QUALITY ASSURANCE -- NON-CONFORMANCE REPORT

Location: Changxing Island, Shanghai, P.R. China**Report No:** NCR-000999**Prime Contractor:** American Bridge/Fluor Enterprises, a JV**Date:** 24-Apr-2011**Submitting Contractor:** Zhenhua Port Machinery Company, Ltd (ZPMC), Changxing Island**NCR #:** ZPMC-0957**Type of problem:**

Reference Description: A joint in Cable Bracket SA6529 was being welded without conforming to the approved WPS root gap opening tolerance

Dear: Mr. Charles Kanapicki
Job Name: SAS Superstructure

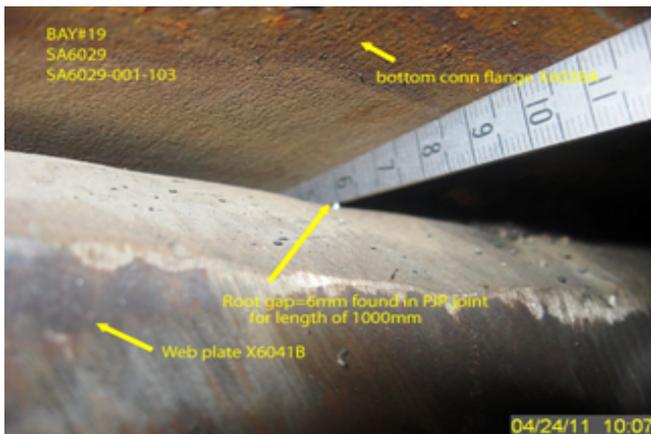
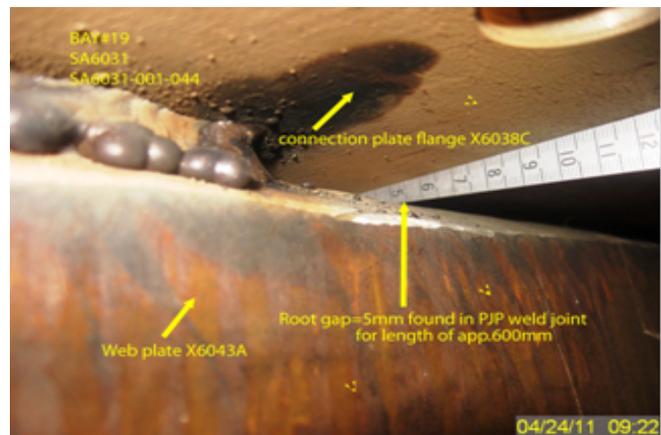
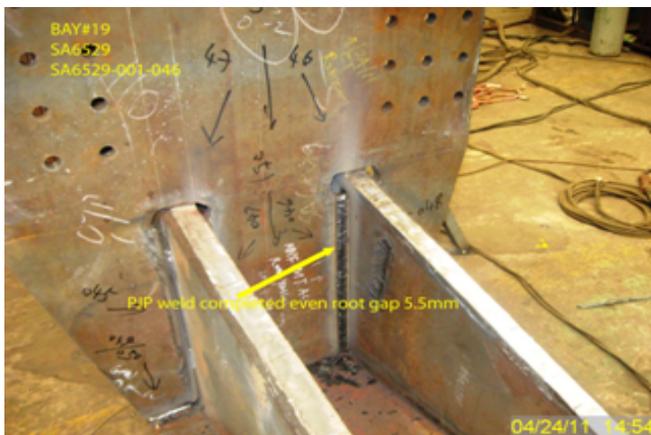
- The fit-up of 3 Partial Joint Penetration (PJP) welds had excessive root openings as described below.
- ZPMC personnel proceeded with welding one of these PJP welds without conforming to the root opening tolerance as stated in the approved WPS.

***Cable Bracket SA6529**

- The PJP weld is identified as SA6529-001-046 (Welded the joint with excessive root opening).
- The Root gap was measured approximately 5.5mm for length of 530mm.
- Web plate (X6549A) connects to Side connection plate (X6545A).

***Cable Bracket SA6031 (Currently at fit-up stage)**

- The PJP weld is identified as SA6031-001-044.
- The Root gap was measured approximately 5.0 mm for length of 600mm.
- Web plate (X6043A) connects to Bottom flange plate (X6038C).

***Cable Bracket SA6029 (Currently at fit-up stage)**

- The PJP weld is identified as SA6029-001-103.
- The Root gap was measured approximately 6.0mm for length of 1000mm.
- Web plate (X6041B) connects to Bottom flange plate (X6038A)

Approved WPS: WPS-B-T-2233-ESAB / WPS-B-T-2232-ESAB indicated that the Root Gap fit-up shall be 0mm with a tolerance of (+3mm, -2mm)

AWSD1.5-2002, Sec.3.3.2: The root opening between parts to be joined by PJP groove welds parallel to the member length (bearing joints expected) shall be zero, or as small as practicable.

Based on TC-RFI-0411 Rev 0 acceptable response to leave this condition as is, ABFJV hereby requests closure of this NCR.

This proposed resolution is acceptable. The documentation received is sufficient and the Department concurs that Non-Conformance ZPMC-0957 is closed.

Contractor issued TC-RFI -0411R0 proposing remedial actions for cable bracket SA6029 but leaving SA6529 and SA6031 sa-is. proposes remedial actions for cable bracket SA6029 as well as leaving SA6529 and SA6031 as-is. Remedial action for SA6029 includes - root pass with SMAW as stated in AWS D1.5, clause 3.3.2.1, MT
